T.I. no.: 2024-19 Updated: -	Topic: Software version 2.6.1
----------------------------------------	--------------------------------------

INFORMATION ON BSP 45 AND NEW SOFTWARE VERSION 2.6.1

SOFTWARE VERSION 2.6.1

Figure 1: Folder structure on USB data carrier and hardware version

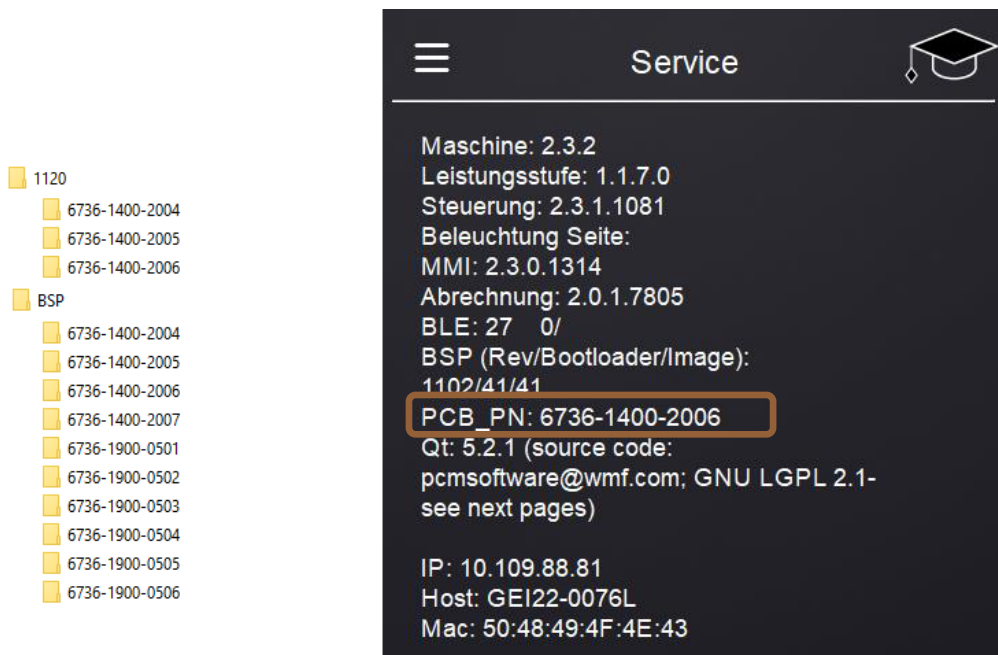
After **BSP_45_new.exe** is extracted, the following folders must be created on the USB data carrier:

Each subfolder corresponds to a hardware version (PCB_PN) and is displayed in the **Info** menu.

Figure 2: Pump cycle setting

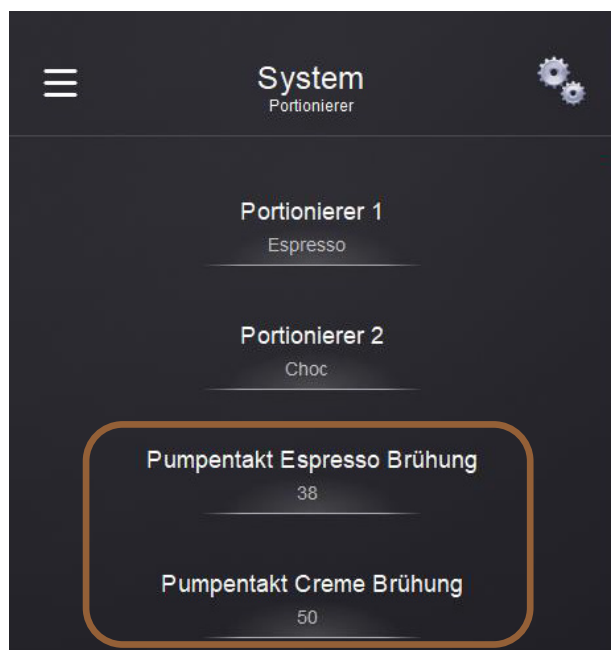
With the new software version, an option for changing the pump cycle and therefore the performance of the oscillating armature pump has been added in order to have additional influence on the brewing time.

The pump cycle can be set separately for all espresso-based and crème-based beverages after entering the service PIN.

System > Portioning device > Pump cycle Espresso brewing (default value 38)

System > Portioning device > Pump cycle Crème brewing (default value 50)

- 38 (lower pump performance)
- 50 (higher pump performance)

Figure 3: Option for adjusting the logo

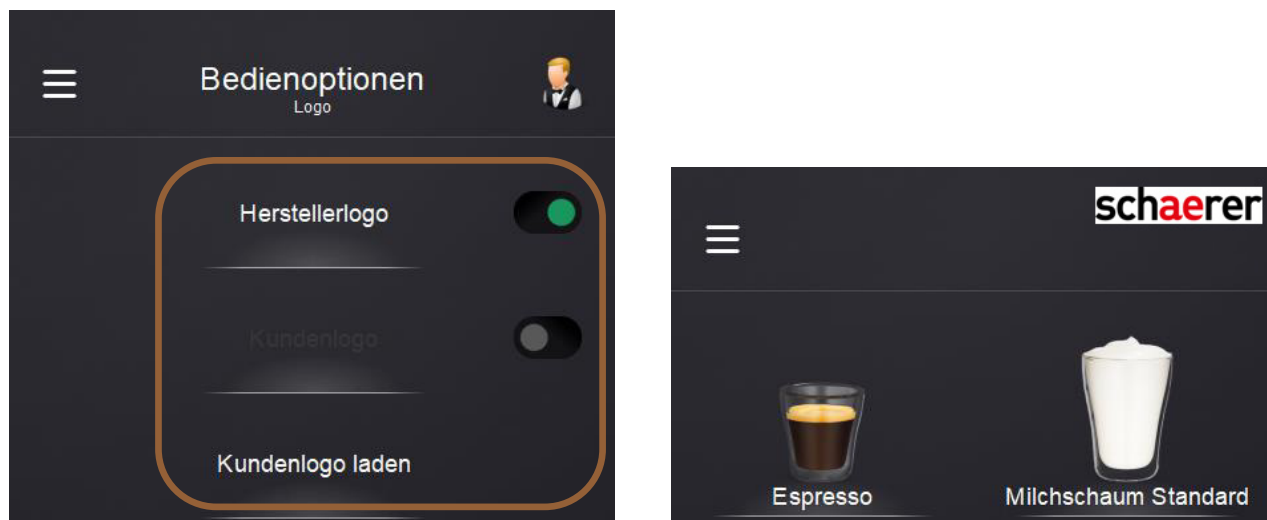
With the new software version, it is possible to show the manufacturer logo and/or a customer logo in the coffee machine display.

The **Customer logo** option is not available until a graphic file with the customer logo has been loaded.

The logo must be no higher than a maximum of 80 pixels. Larger logos are automatically scaled to this size.

Figure 5: Override function activated

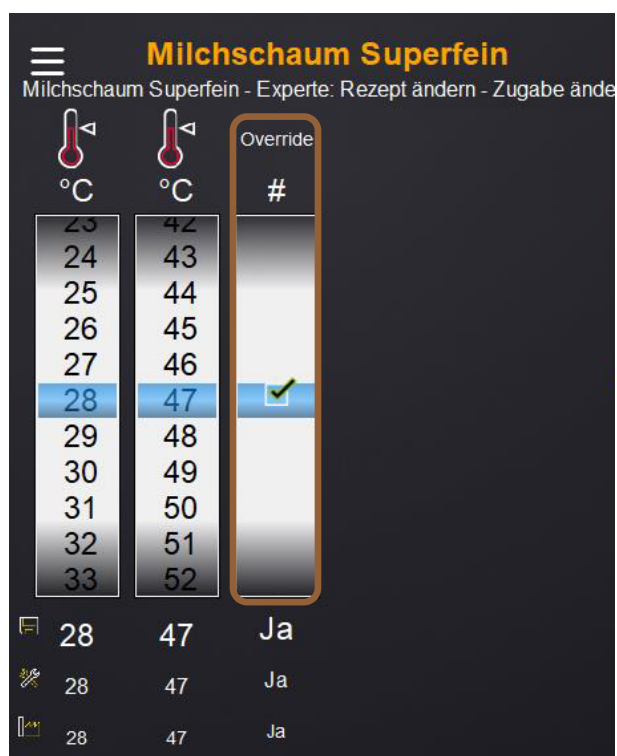
The **SuperSteam** override function did not work with earlier software versions.

Once the temperature set in the recipe had been reached, it was not possible to continue heating when the **SuperSteam** button was pressed.

This behavior is corrected in the new software version.
